ADDENDUM 04

Issued: April 24, 2024

RE: Boney Courthouse Generator Replacement, ANC-C-2024-0005

**ARCHITECTURAL
DETAILS**

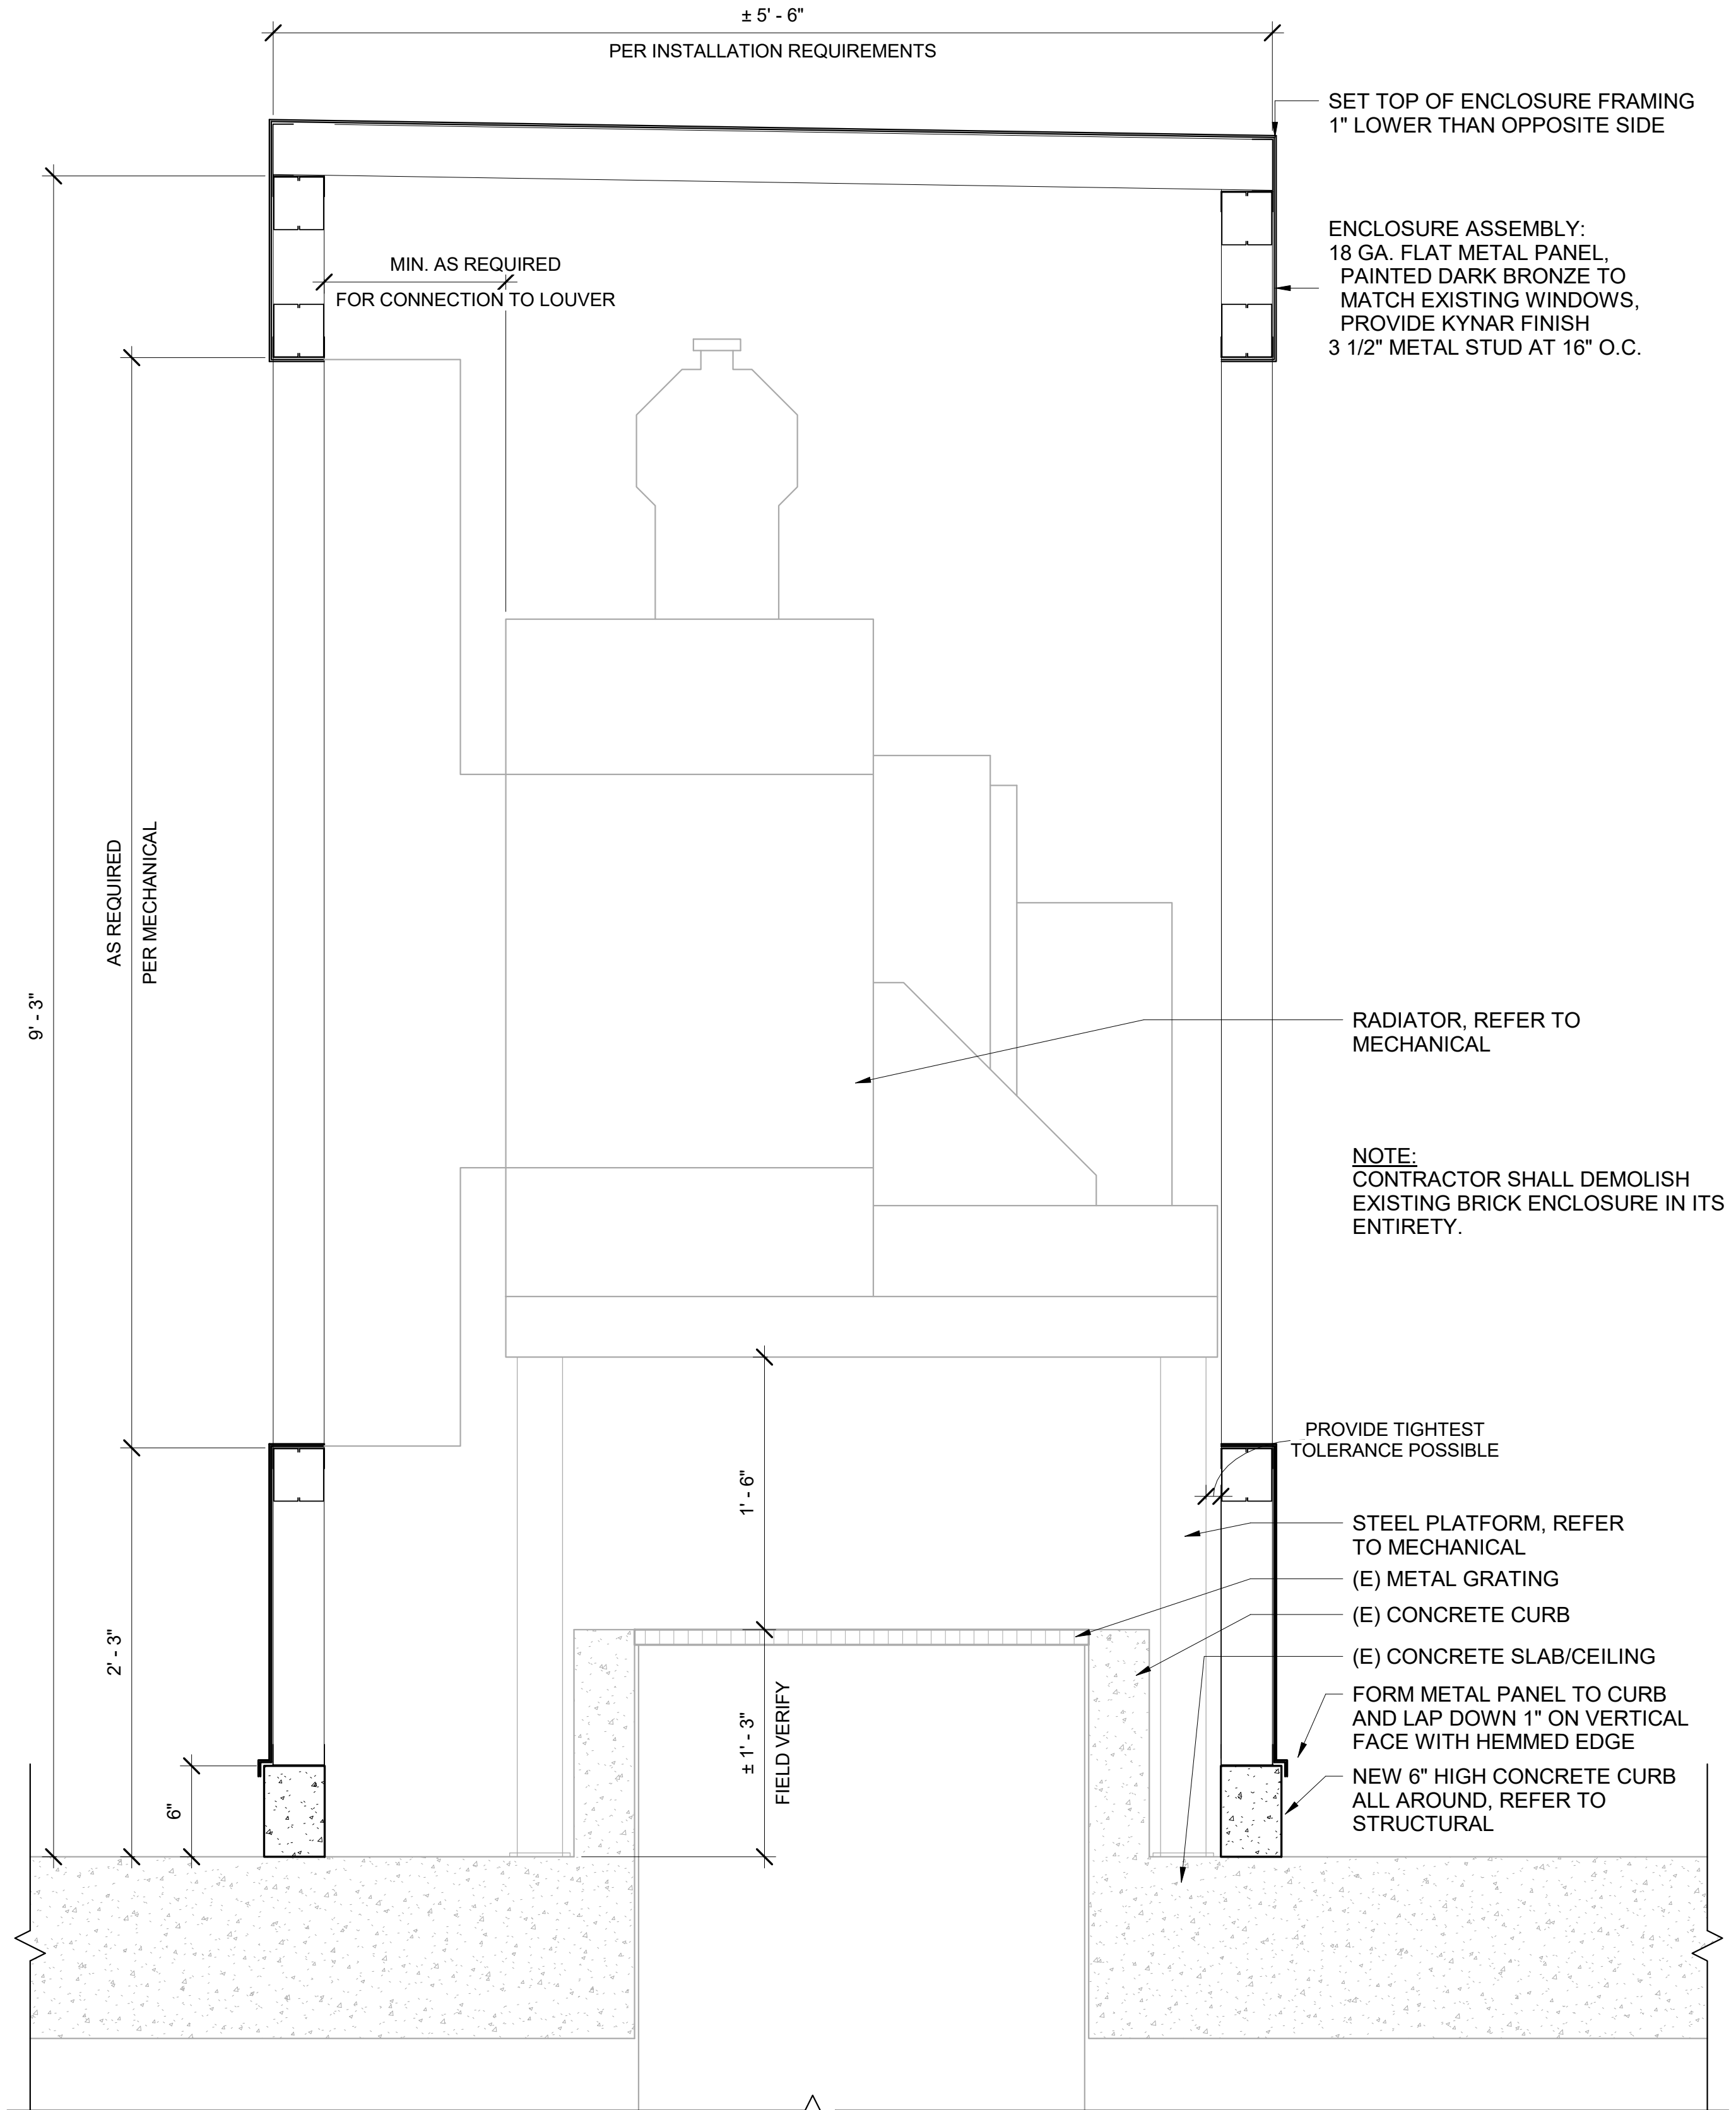
ADD sheet A101 Architectural Details.

13. Question: *A portion of Sheet Note 2 on M202 states "Contractor to coordinate w/Owner for procurement of masonry wall fascia for radiator enclosure." Is the intent for the Owner to furnish the matching masonry wall fascia material, to be installed by the contractor? Or is the masonry fascia contractor furnished and contractor installed?*

14. Question: *Details 2/M202 and 1/M301 indicate that the existing masonry wall enclosure must be enlarged both vertically and horizontally. Does this mean the top and sides of the masonry enclosure will also need to be demolished and newly constructed to be enlarged in order to match the new footprint and 8'-2" height of the enlarged enclosure? Also, will the enlarged enclosure require demolition of adjacent building masonry fascia as well as exposed aggregate site concrete? The exposed aggregate site concrete sits directly on top of the basement/tunnel's structural concrete waffle lid.*

15. Question: *Typically masonry fascia is fastened to a wood or metal framing system. Currently none is shown. Is the intent for the contractor to construct new framed walls*

Response: Refer to Architectural sheet added to the Drawings under this addendum.

Response: Refer to Architectural sheet added to the Drawings under this addendum.

Response: Refer to Architectural sheet added to the Drawings under this addendum.

1ST FLOOR PARTIAL FRAMING PLAN AND DETAILS

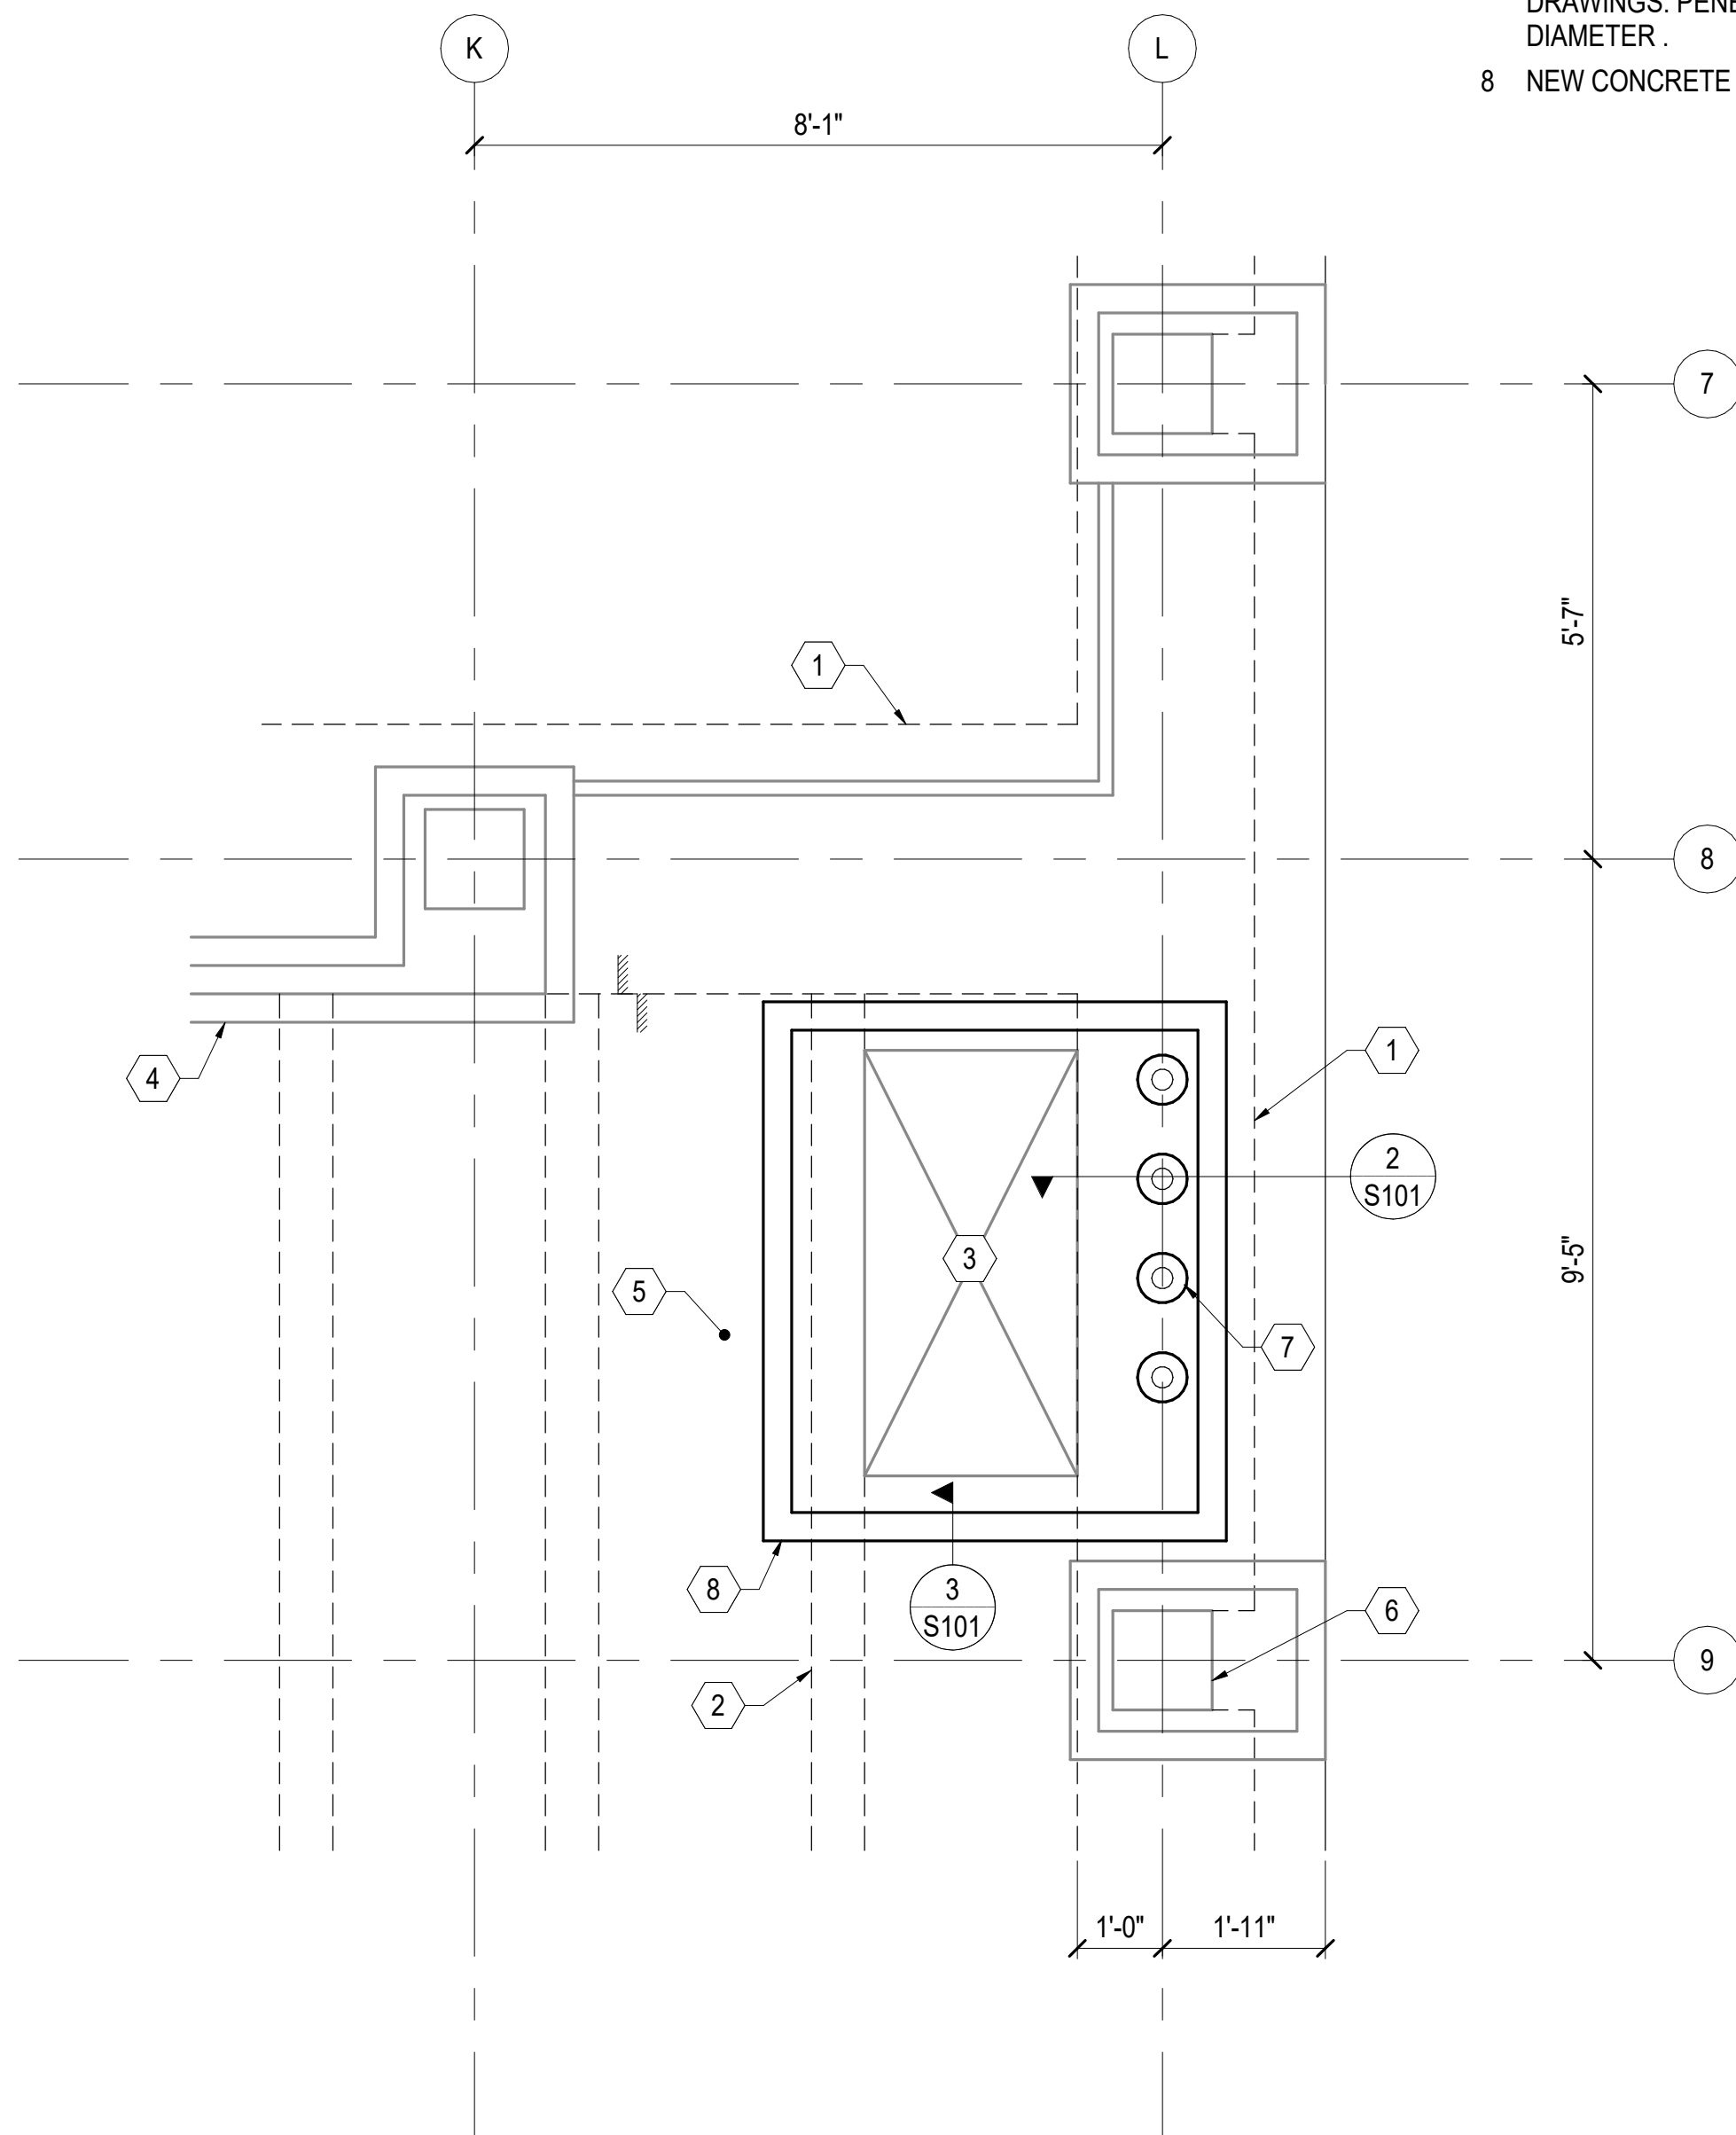
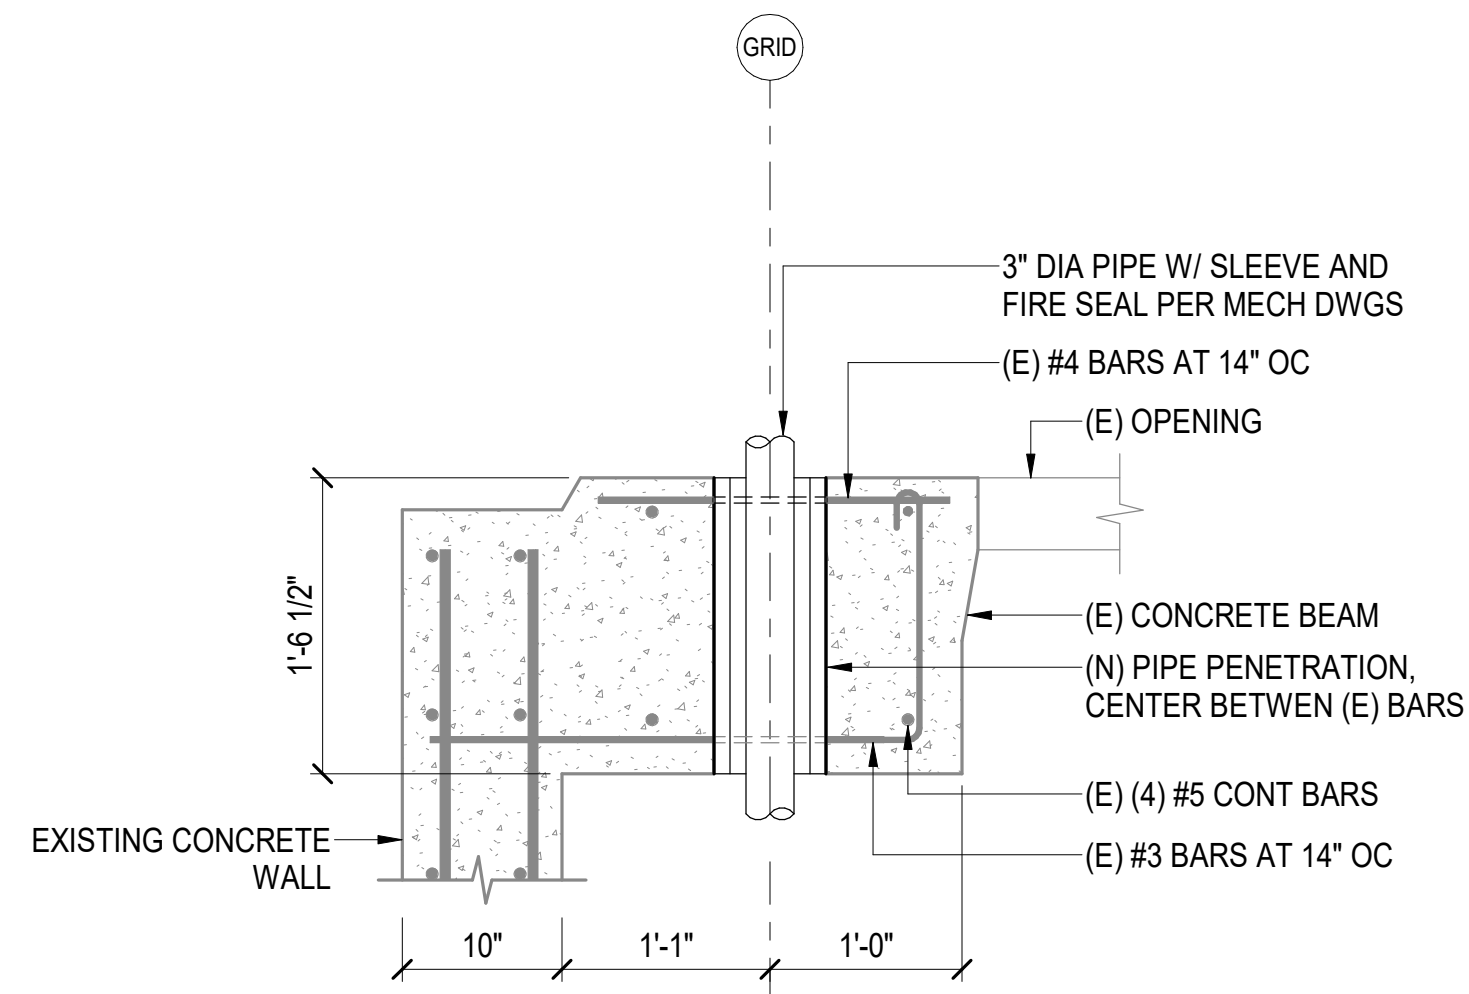
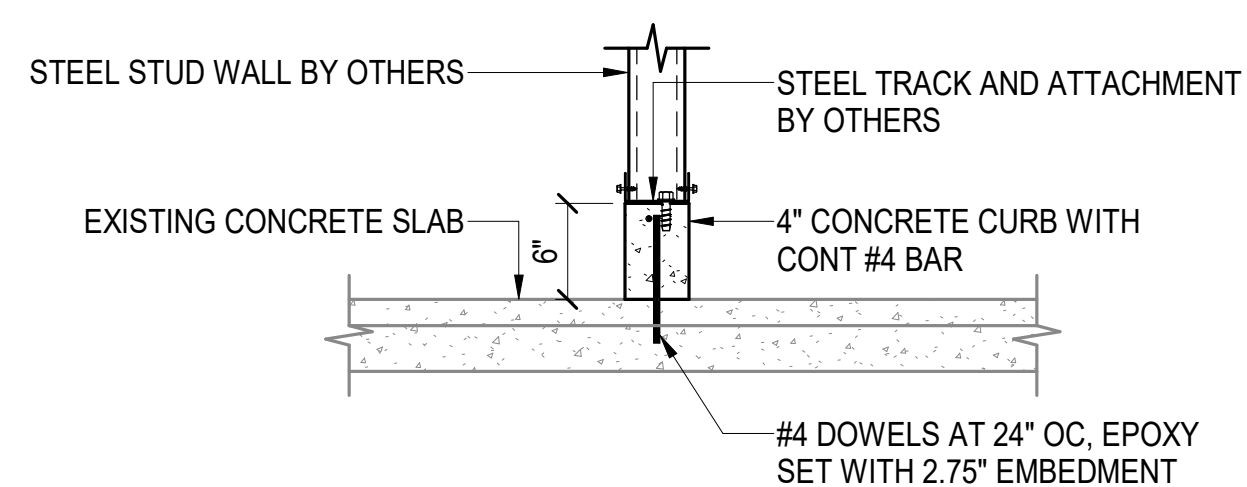
ADD sheet S101 1st Floor Partial Framing Plan and Details.

12. Question: *Detail 1/M202 shows (2) 3" ACCR/ACCS and (2) 3" ECR/ECS piping penetrations noting "sleeve and seal piping penetrations up through floor." Our understanding is that these (4) penetrations are to be new/added as part of this project, and will be penetrating the existing structural concrete ceiling comprised of a concrete waffle slab plus an unknown concrete thickness above on the exterior of the building. Please provide a structural penetration detail to account for this specific condition to include, but not be limited to, the total anticipated length of each core (thickness of total structural concrete build-up), the required spacing of each core, the total core diameter sized to accommodate the piping plus the required sleeve and insulation, and any requirements associated with X-raying the concrete given that cutting through structural rebar is a strong likelihood given the structural nature of the tunnel's roof/ceiling.*

26. Question: *Are there any known special requirements for penetrating and anchoring into the existing tunnel for the new radiator ECS/ECR and ACCS/ACCR piping and radiator enclosure?*

Response: Refer to Architectural and Structural sheet added to the Drawings under this addendum.

Response: Contractor shall perform non-destructive testing to locate existing rebar and cannot drill through any existing rebar. Refer to added structural drawing for general notes regarding anchors.
